Town of Hampden

Planning Board

Wednesday, June 12, 2019, 7:00 pm

To: Planning Board
From: Karen M. Cullen, AICP, Town Planner
Date: June 4, 2019

Excerpt of Honey Hill Estates preliminary subdivision plan

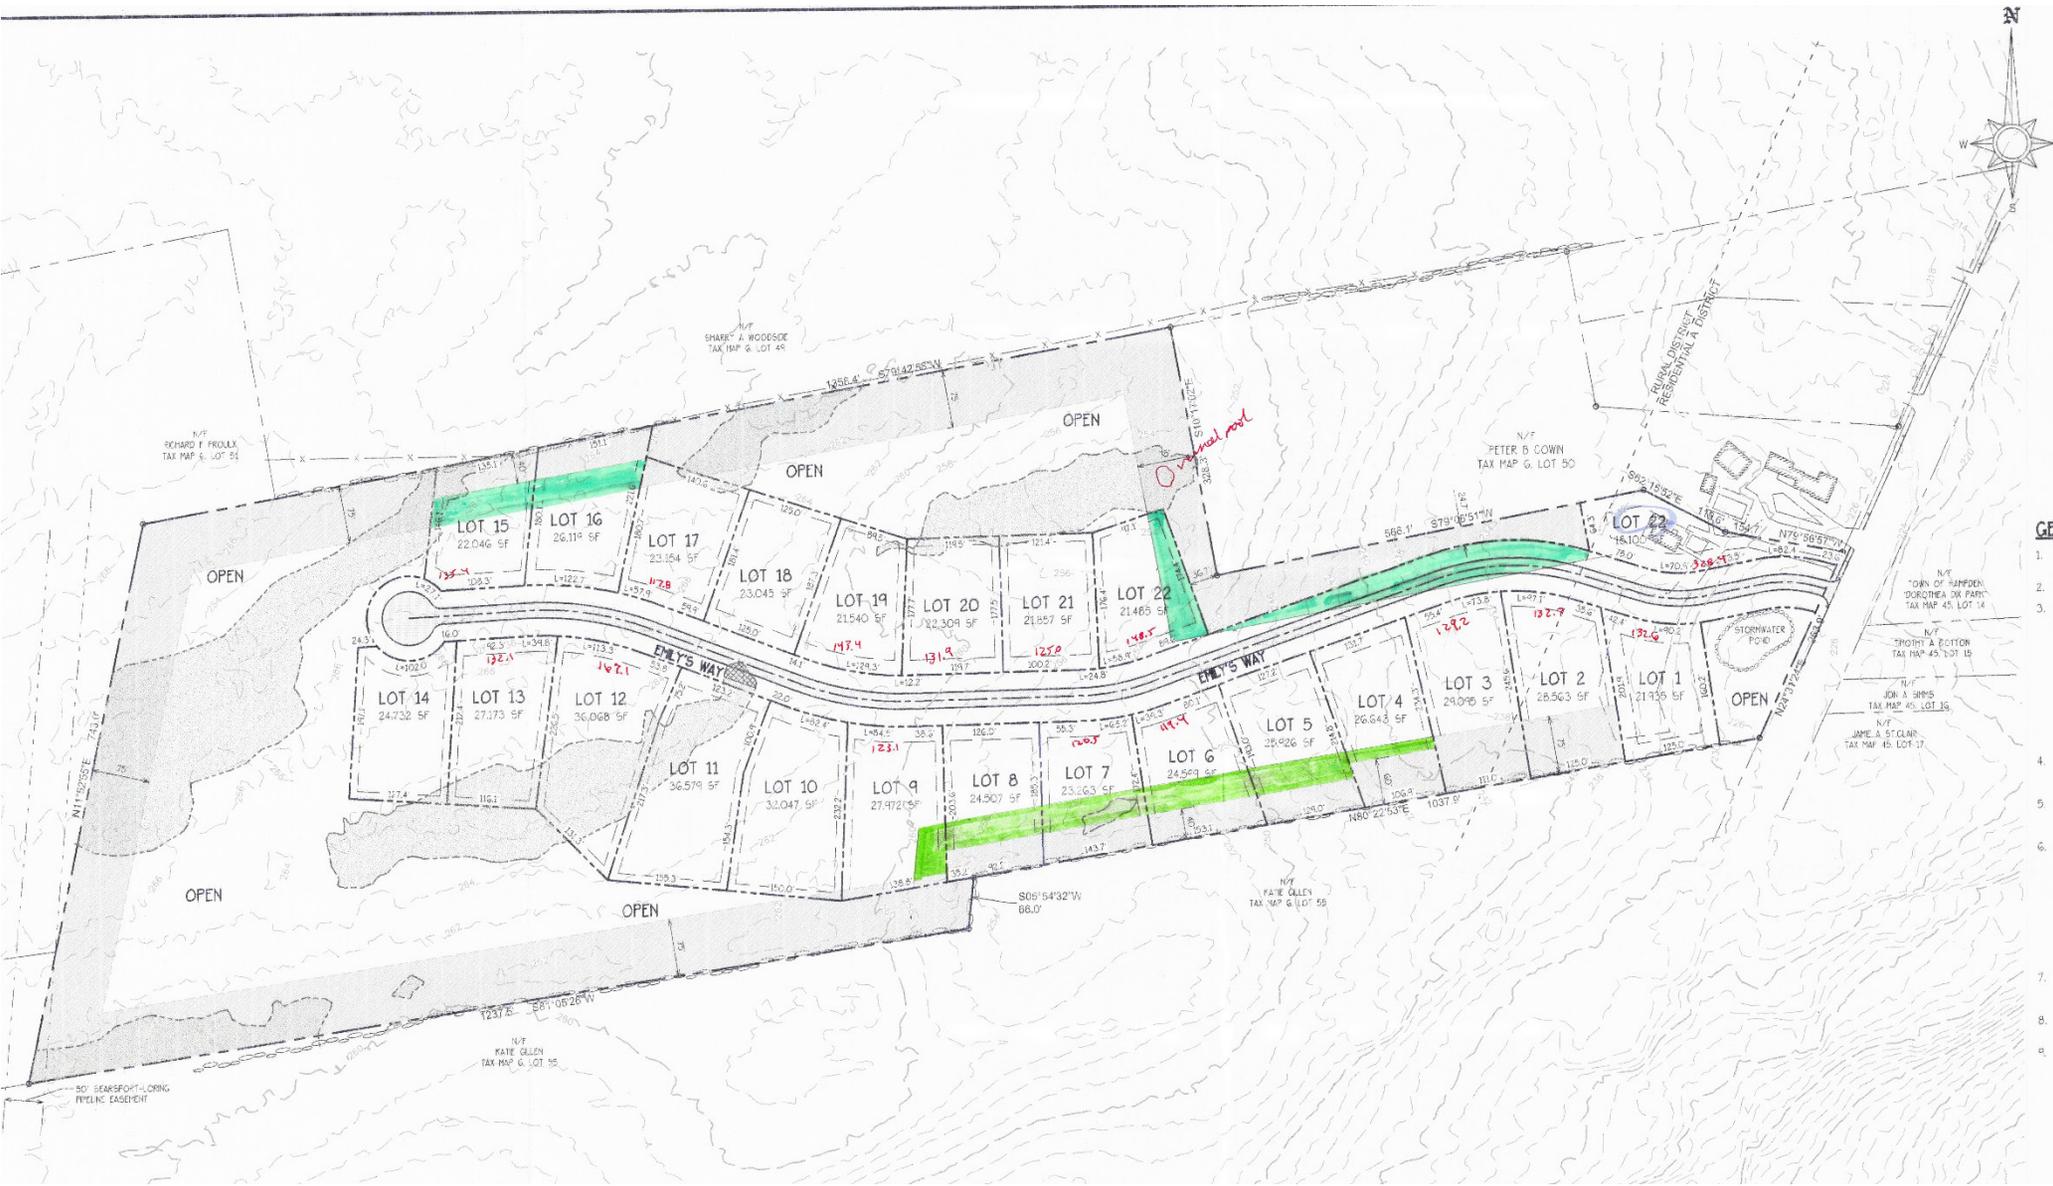
In summary, there are a number of items to be addressed before the Board will be able to take action on this preliminary plan. I would suggest that decisions on the issues related to the cluster requirement for buffering as detailed on the second page of this report are paramount to moving this application forward, as there is the potential for a redesign of the subdivision depending on how the Board handles these issues.

Green highlight areas show where reductions to the required 75' buffer are requested.
